PLAN AMENDMENT AND REZONING APPLICATION OLIVER

9918 – 111 Street NW

To allow for a high rise, high density residential building

RECOMMENDATION AND JUSTIFICATION

DIAGRAM OF SEPARATION SPACE AS PROPOSED

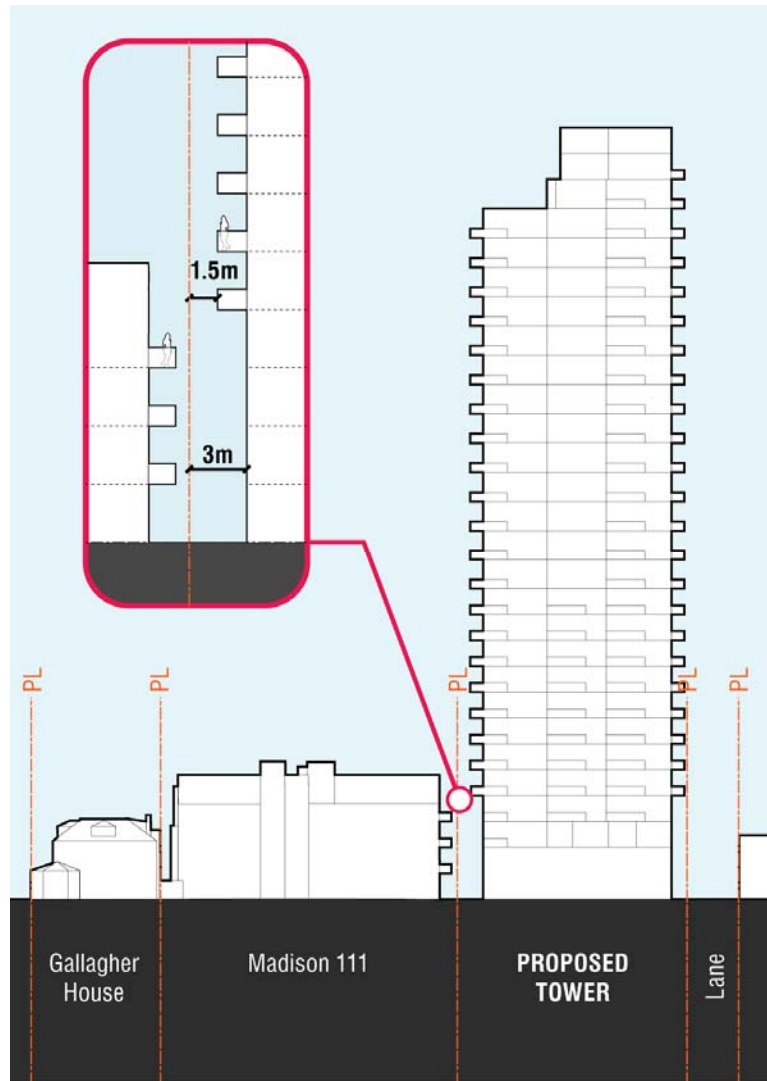
The abutting site to the south contains a 4-storey apartment development with balconies and rooftop terraces on the north façade directly facing the subject site.

The existing conditions require that the future development be properly screened, set back, and stepped back to maintain privacy, to properly transition the tower bulk to the existing scale of development, and to maintain the liveability of existing residents. The proposed does not achieve this, and provides a minimal setback that would be considered appropriate for a low rise building, not a high rise building. There are no stepbacks for the building, which will place the full bulk and height of the tower directly adjacent to the existing residence. This close proximity combined with the lack of podium transition also creates a condition where the impacts on wind and airflow caused by the introduction of the tower are borne by the adjacent building, including their amenity areas.

THE HENDRIX WITH TOWER SETBACKS LOOKING EAST

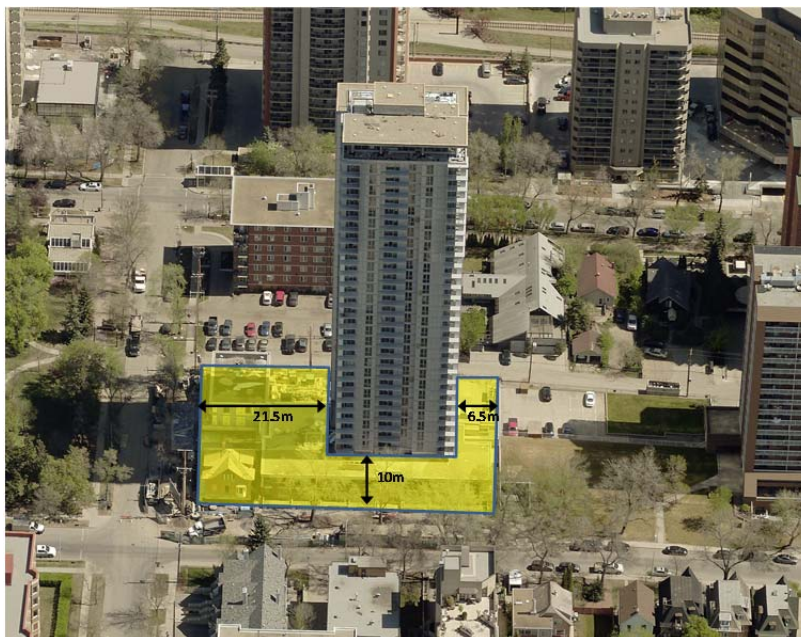
The Hendrix was able to provide substantial space between the tower and the edges of the property based on a land size that was twice as large and a floor area ratio that is half as much. This space was used for a podium of townhomes and also included the retention of a designated heritage house and a publically accessible open space on site. All of these features combine to ensure that the addition of significant density in a very urban setting is done with sensitivity and compatibility.

The Hendrix (left) shows how the tower portion is well within an appropriately sized site allowing for sensitive and compatible transitions to adjacent properties and the street.

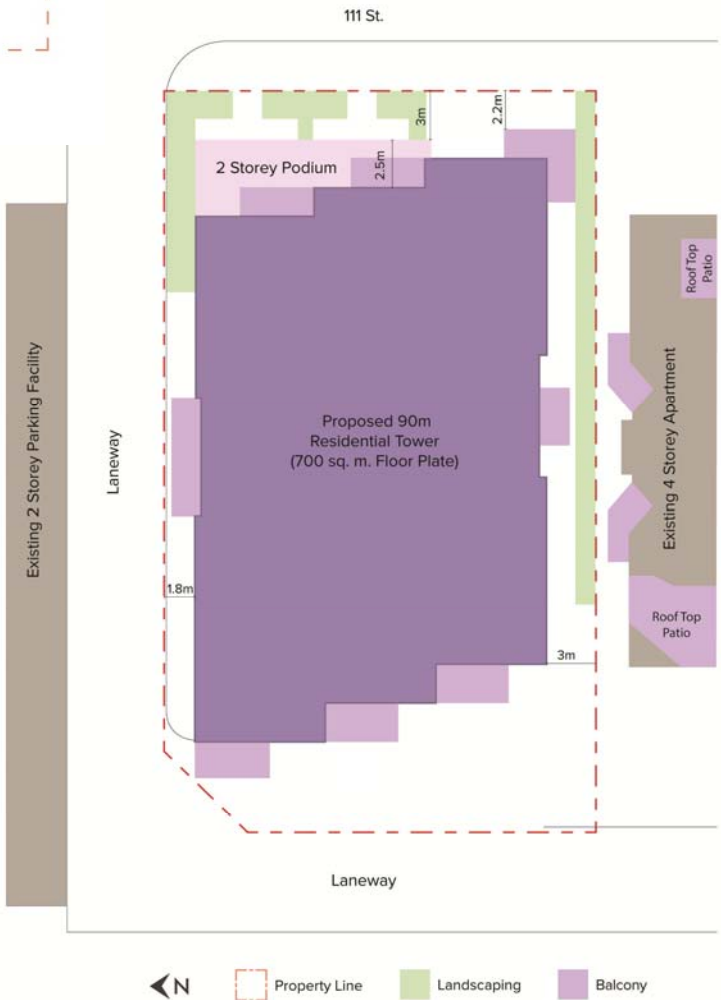
The proposed tower (right) shows how the tower extends very close to the property lines with very little transition or open space.
